Gunstfontein Wind Energy Facility and associated infrastructure, Northern Cape Province

Motivation for amendment of Environmental Authorisation

DEA Ref.: 14/12/16/3/3/2/826

May 2019

Figure 2.1: Updated wind farm layout - A3 Map included in **Appendix H**.

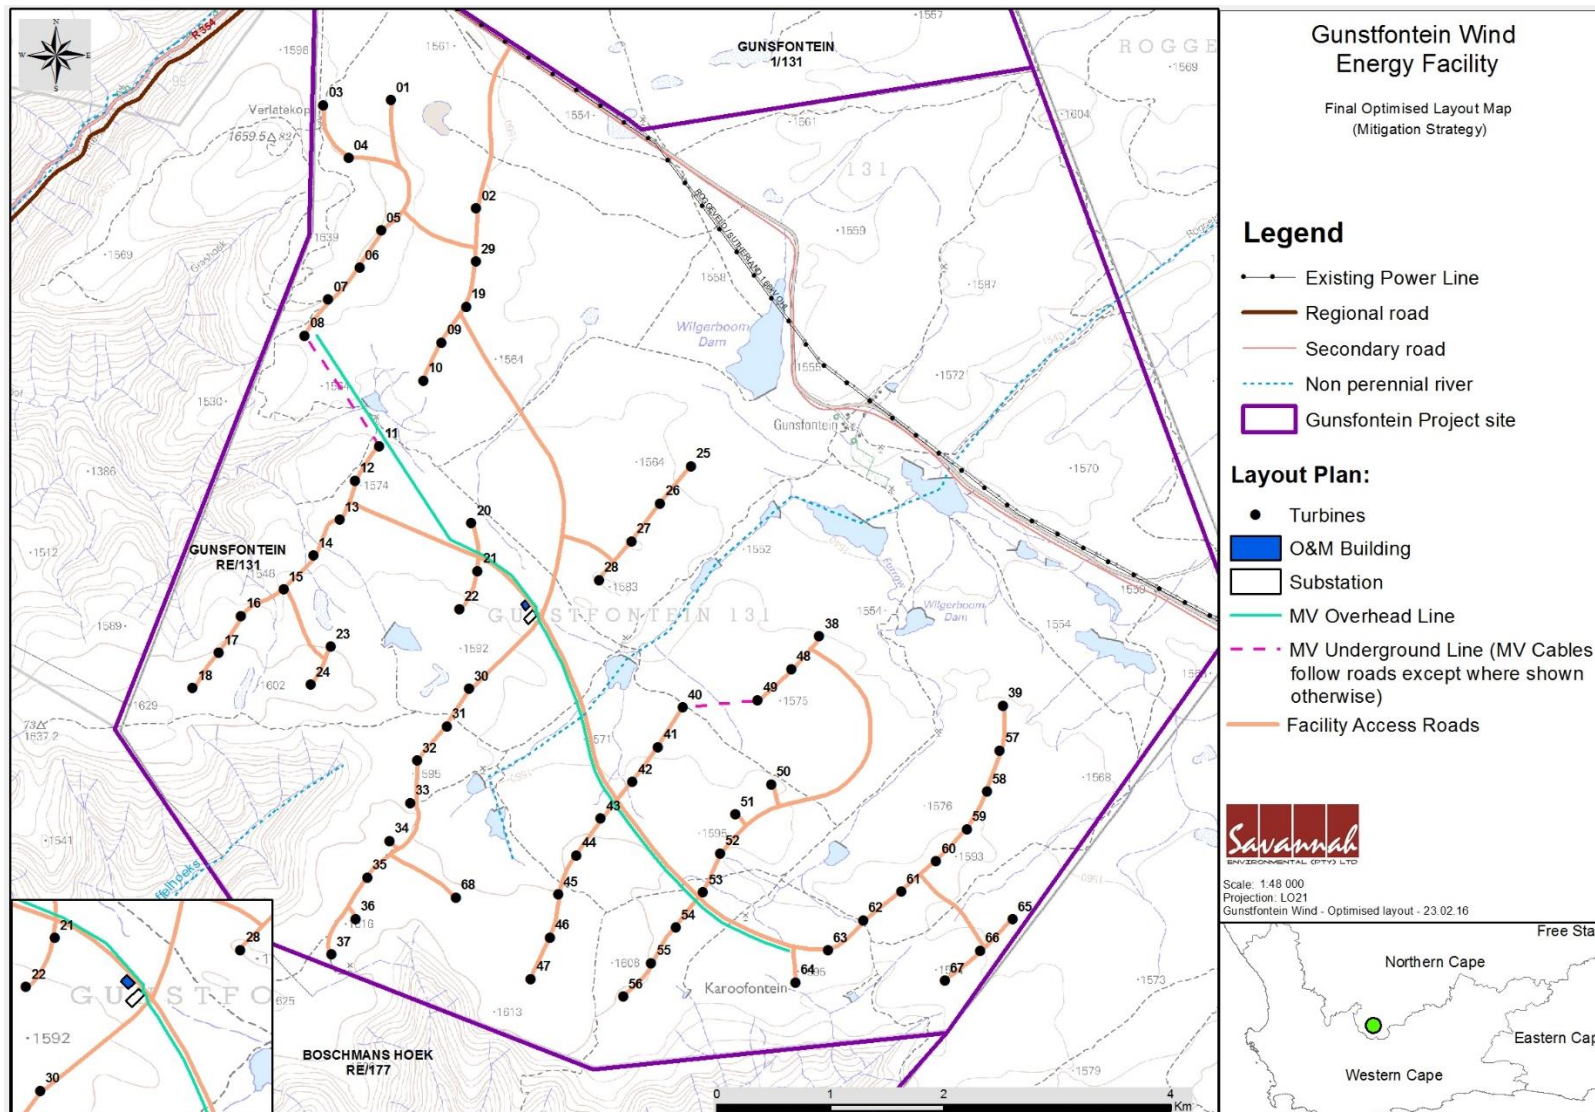
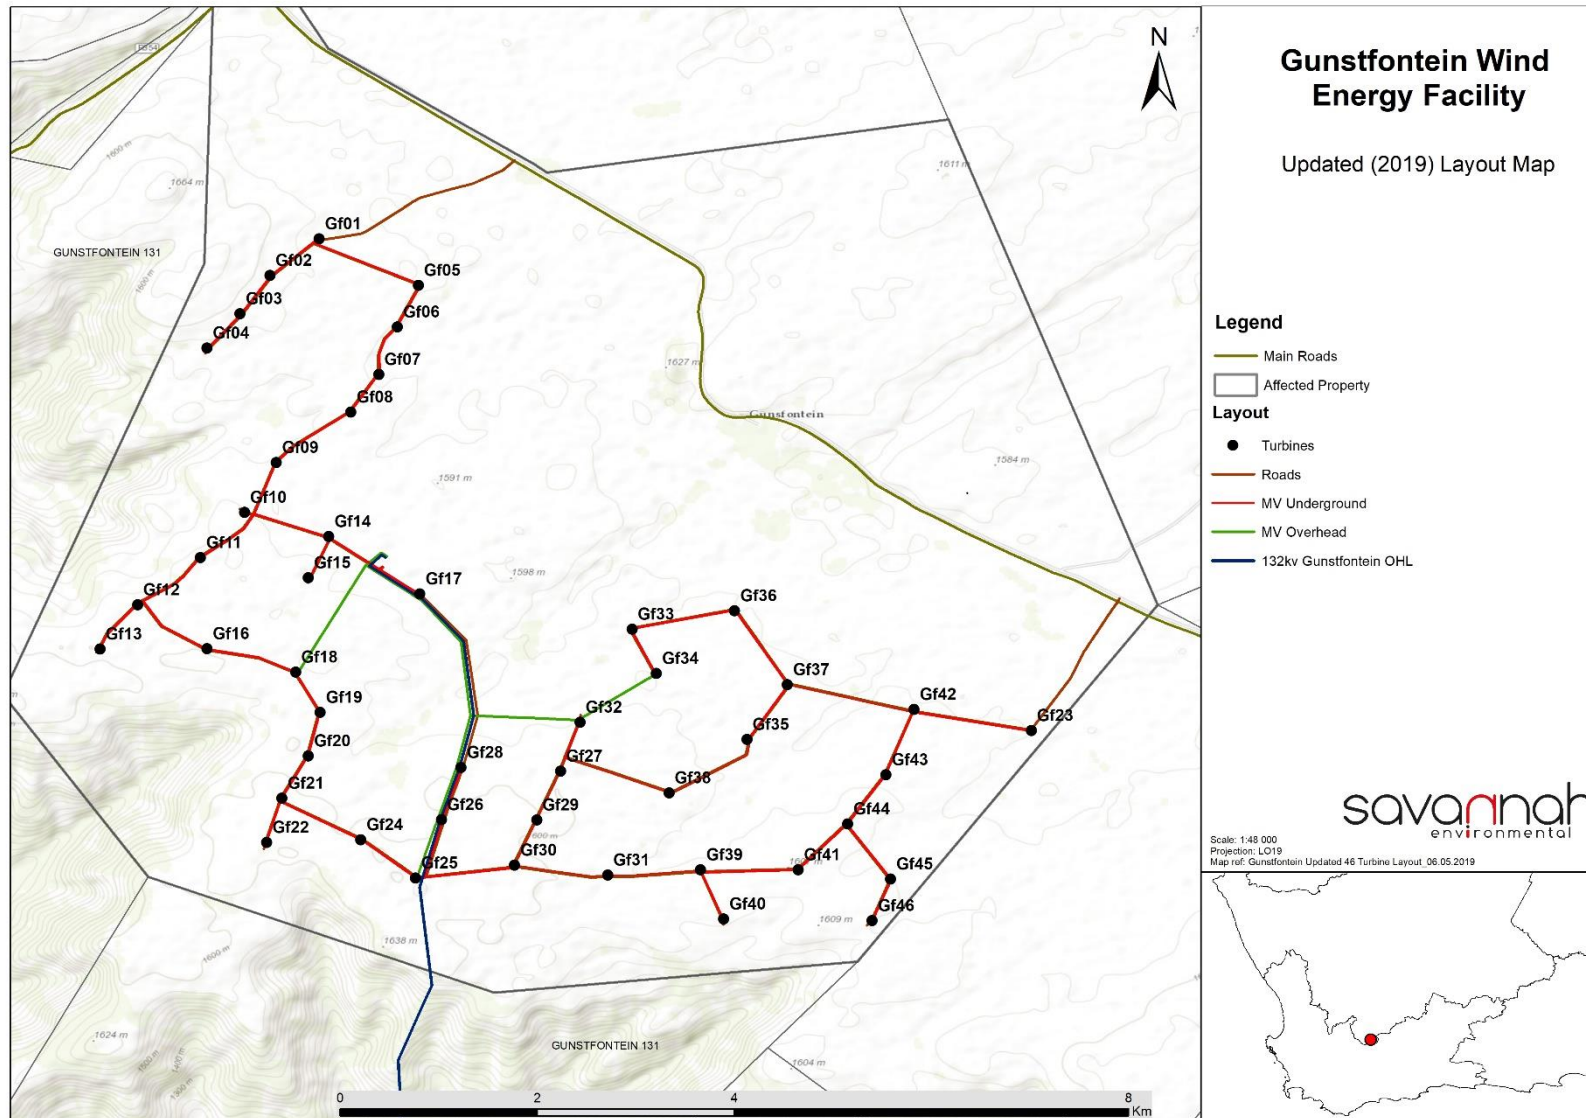
Following the removal of turbines 14-18, 23,24, 30-37, 44-47, 55, 56 and 68, the layout was amended. The layout amendment is presented below. It must be noted that this layout was not approved in the EA and therefore a final layout is still required to be submitted in accordance with Condition 13 of the EA dated July 2016.

The proposed amended layout is presented in Figure 2.1. It must be noted that this layout will be finalised and submitted to the DEA for review and approval (in accordance with Condition 13 of the EA) once a turbine supplier has been selected for the project.

Component	Authorised specification	Amended specifications
Rotor diameter	140m	Range up to 180m
Hub height	120m	Range up to 150m
Site Access	Access to site: 32°32'12.91" S, 20°39'06.97" E	Site access point 1: 32°32'32.67" S, 20°39'40.95" E Site access point 2: 32°34'56.62" S, 20°42'59.77" E
Turbine Capacity	none	Up to 6.5MW

Figure 5.1: The revised 46 Turbine layout with avifaunal sensitivities and exclusion zones.

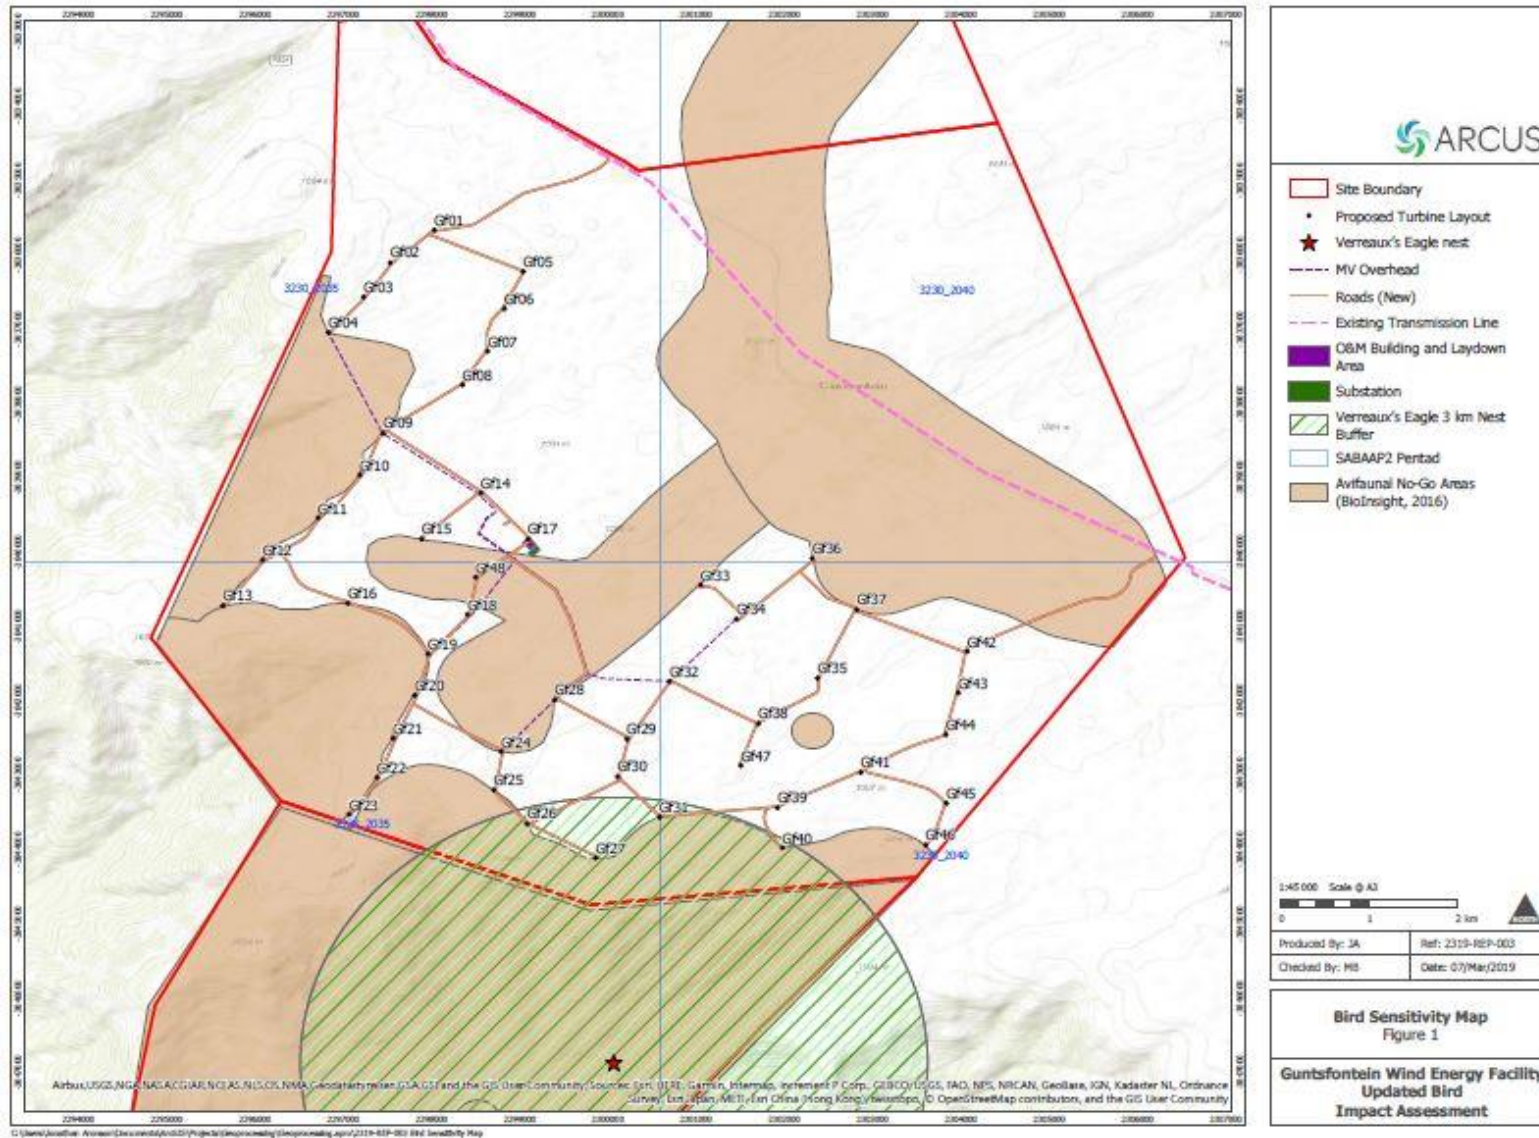
It was found that the new layout adheres to the no-go areas given by BioInsight (2016). Therefore, this 'embedded design mitigation' was already considered in the 'Without Mitigation' rating. However, Figure 5.1 (in the avifaunal amendment report contained in Appendix H shows that one turbine (Gf48) is situated within a no-go area, while 24 turbines (Gf04, Gf09-Gf13, Gf15, Gf16, Gf19-Gf28, Gf31, Gf33, Gf36, Gf37, Gf40 and Gf46) are situated on the boundary of the no-go area. Turbine Gf48 must be removed from the no-go area, while all turbines must be situated at least 70 m back from the no-go boundary (and preferably 90 m back) in order to reduce the length of blade extending into the airspace above the no-go area. A 3 km No-go buffer should be placed around the Verreaux's Eagle nest site (NEGN03 in Appendix V of BioInsight, 2016) (Figure 5.1). All turbines should be located at least 70 m beyond the boundary of this buffer and

Figure 5.2: The updated layout with bat sensitive and bat no-go areas.

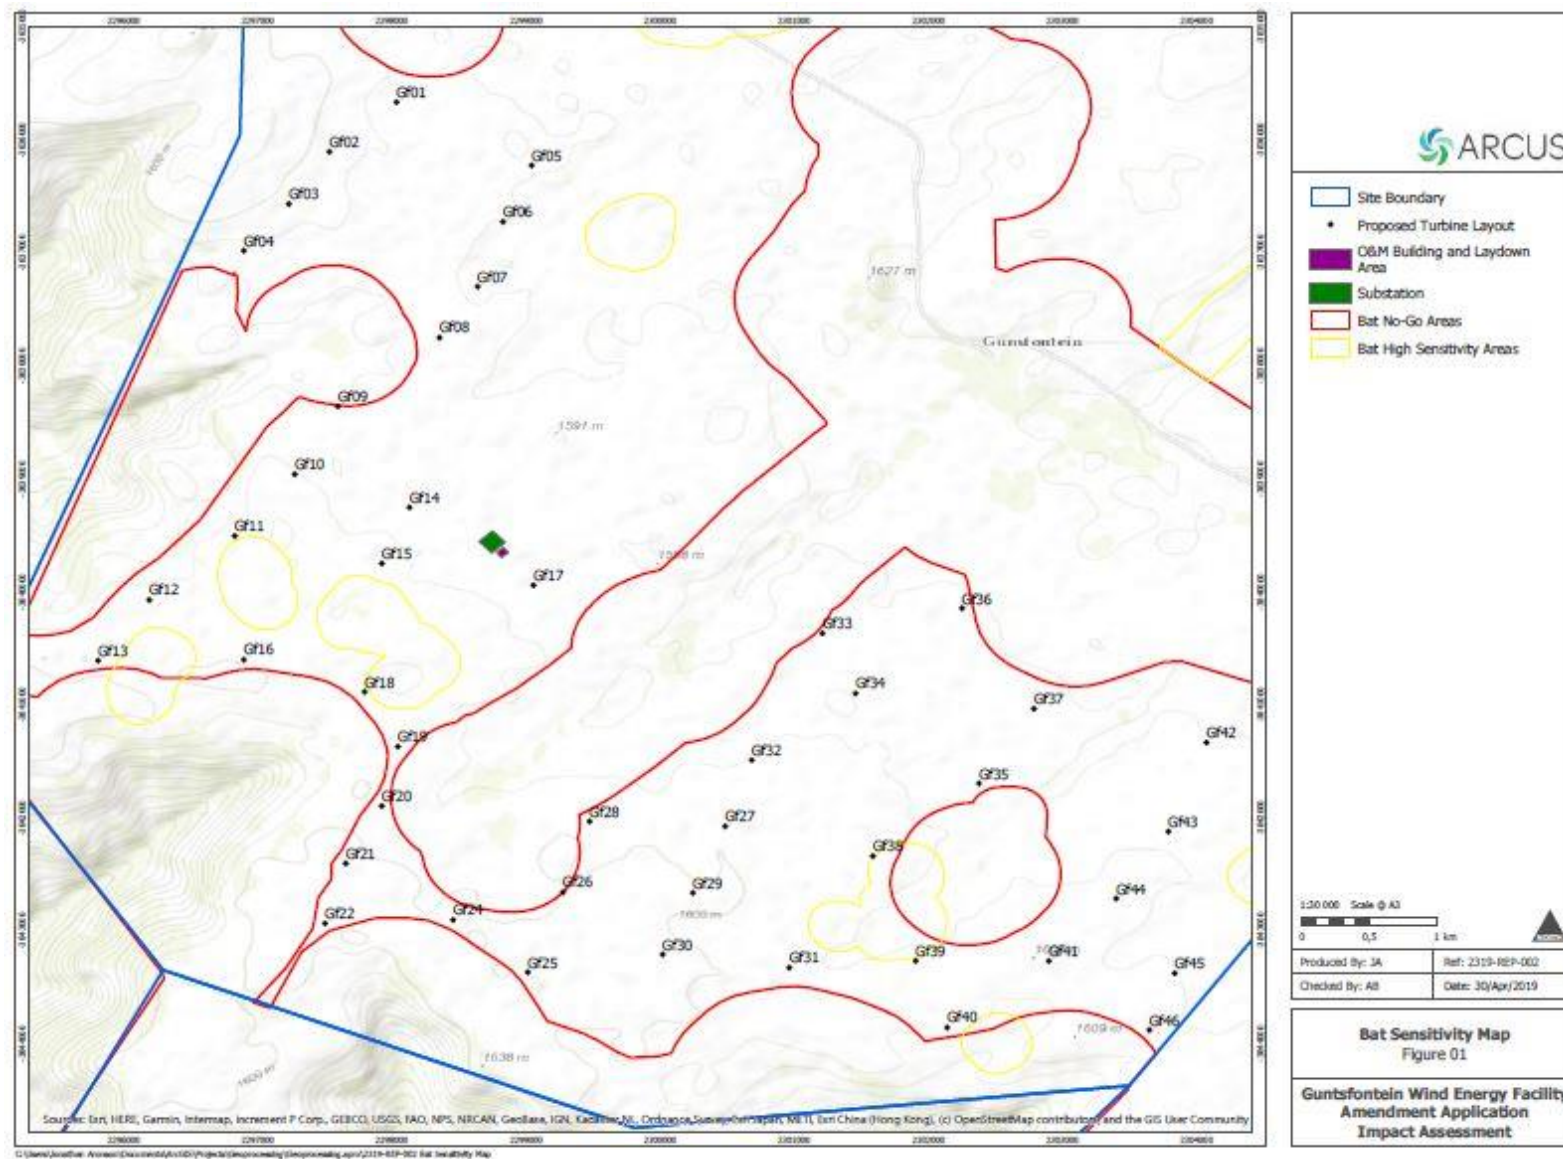
The key initial mitigation measure that should be implemented at the Gunstfontein WEF would be adherence to the updated sensitivity map (Figure 5.2). The exact combination of turbine dimensions that will be selected is unknown but depending on the size of the turbines selected, turbines may need to be micro-sited to prevent the blade tips intruding into bat buffers as several turbines border bat sensitive areas (Figure 5.2). The final layout will therefore need to be assessed by a bat specialist to ensure this is adhered to once the turbines are chosen. This can be done during the pre-construction specialist walk-through and micro-siting process and must include the specialist mapping the final layout and determining if all turbine blades are outside bat buffers. Any turbine micro-siting will need to be done before construction. Residual impacts that occur will need to be evaluated during the operation phase using carcass searches to monitor actual impacts. As a result, the amendment is supported from a bats perspective.

Figure 5.3. Revised and refined sensitivity map of the Gunstfontein WEF site, depicting the amended layout of the facility. No parts of the development are within the no-go area.

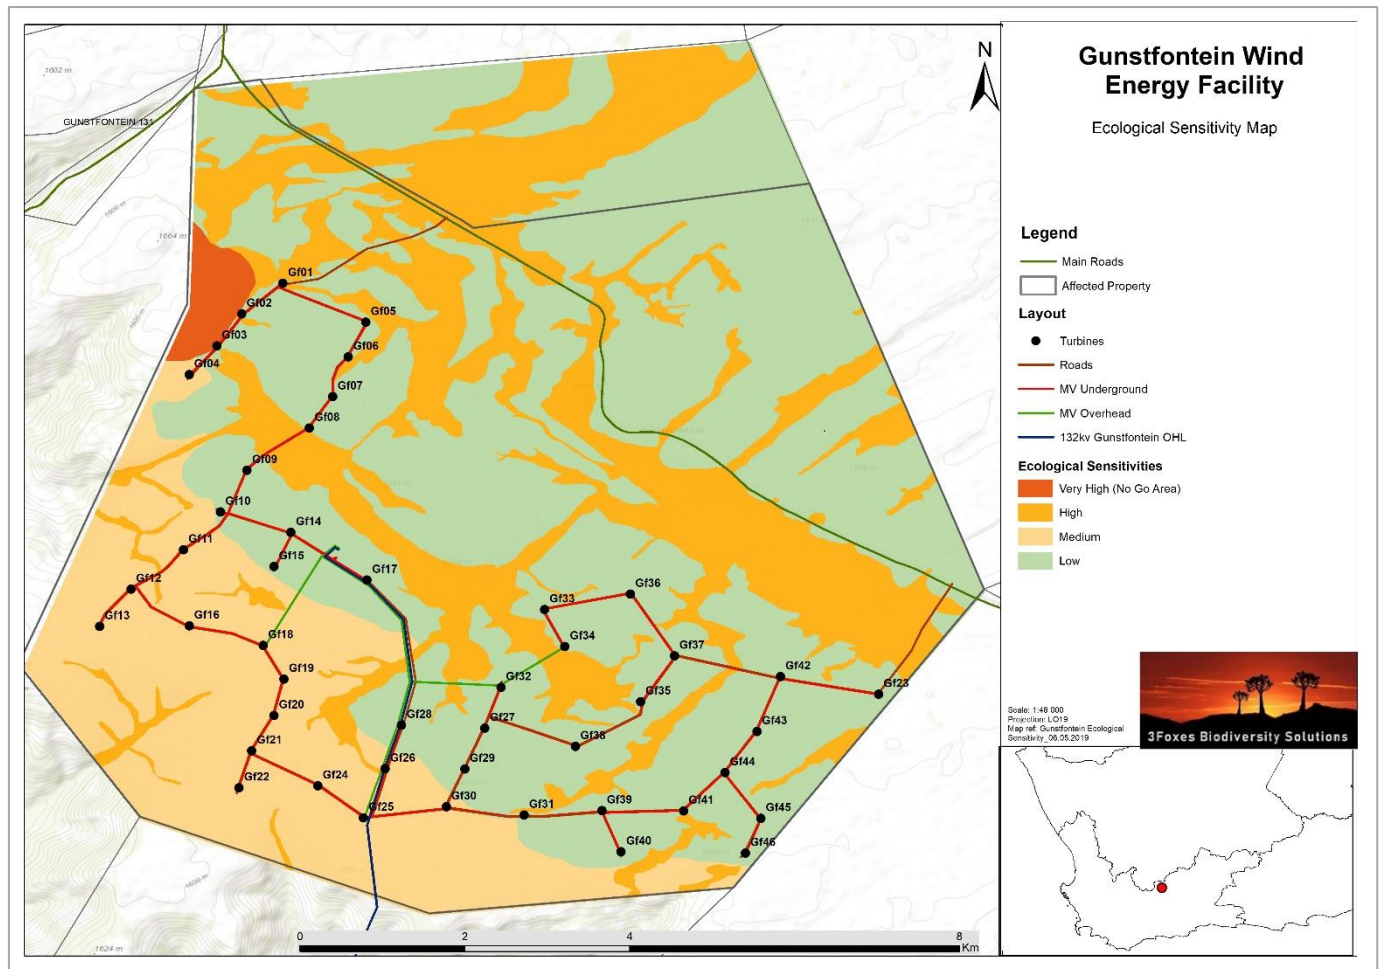
The revised layout for the amendment and the revised sensitivity mapping as produced for the amendment is provided in Figure 5.3. The revised sensitivity mapping is based on the original ecological study by Todd (2016), the review and field assessment of MacDonald (2017), as well as the specific field assessment that was conducted for the current assessment on the 16th of January 2019. During the field assessment for the current study, those areas that had previously been identified as high or very high sensitivity⁸ were checked and where necessary refined in the field and specific note was taken of the presence of species or habitats of conservation concern in these areas. Where appropriate, the sensitivity of these areas was adjusted upwards, downwards or kept the same as necessary. This information was provided to the developer in the form of the revised sensitivity map, which was then used to inform the layout for the amendment. In addition to the sensitivity mapping, to ensure that the impacts associated with the project remain within acceptable bounds, limits of acceptable change associated with each sensitivity class were provided to the developer. This provides a guide for the developer in terms of ensuring that the spatial distribution of impact associated with the final layout is appropriate with respect to the sensitivity of the site. In addition, it provides a benchmark against which impacts can be assessed and represents an explicit threshold that when exceeded indicates that potentially unacceptable impacts may have occurred. The updated (including revised turbine positions and additional access road)⁹ turbine layout is presented below in Figure 5.3, along

The final development footprint in relation to the above limits of change are listed below in Table 5.3.2. The extent of the development within each sensitivity class is well-within the specified limits of acceptable change and as such, there are no fatal flaws associated with the amended layout. As there are also no turbines or other development features within the mapped no-go areas, no specific recommendations are made with regards to relocating any of the turbines or other features of the layout. As such, the final layout as provided for the amendment is considered acceptable with regards to the identified sensitive features and general sensitivity mapping at the site.
